## RENESAS TECHNICAL UPDATE

Product Category	MPU / MCU		Document No.	TN-SH7-A758A/E	Rev.	1.00
Title	Notes on usage of the RCAN-ET module		Information Category	Technical Notification		
Applicable Product	SH7286 Group	Lot No.		SH7280 Group Hardware Manual Rev. 1.00 (REJ09B0393-0100)		
		All lots	Reference Document

Please be aware of the following notes on usage of the RCAN-ET module for the SH7286 Group.

Figure 1 Procedure for Writing Mailbox upon Reception of CAN Data

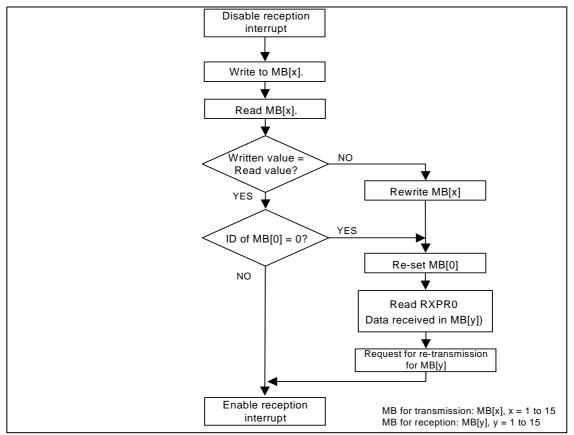
When writing to a mailbox is attempted upon completion of the 7<sup>th</sup> bit of the EOF for received data, there is a possibility that this will result in clearing of the control 0 register of mailbox 0 and data not being written to the given mailbox, or in the written value not being reflected correctly in the given mailbox. To avoid these phenomena, follow the procedure shown in figure 1 when writing to a mailbox upon reception of CAN data.

Figure 2 Procedure for Reading Mailbox upon Reception of CAN Data

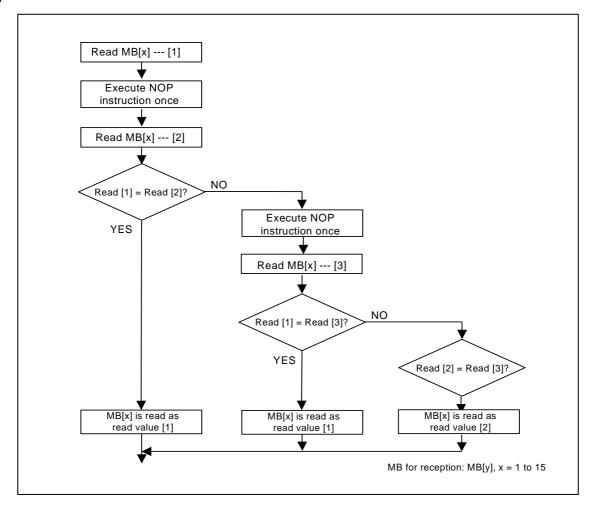
When reading of a mailbox is attempted upon completion of the 7<sup>th</sup> bit of the EOF for received data, there is a possibility of the value read out being incorrect. To remove this possibility, follow the procedure shown in figure 2 when reading a mailbox upon reception of CAN data.
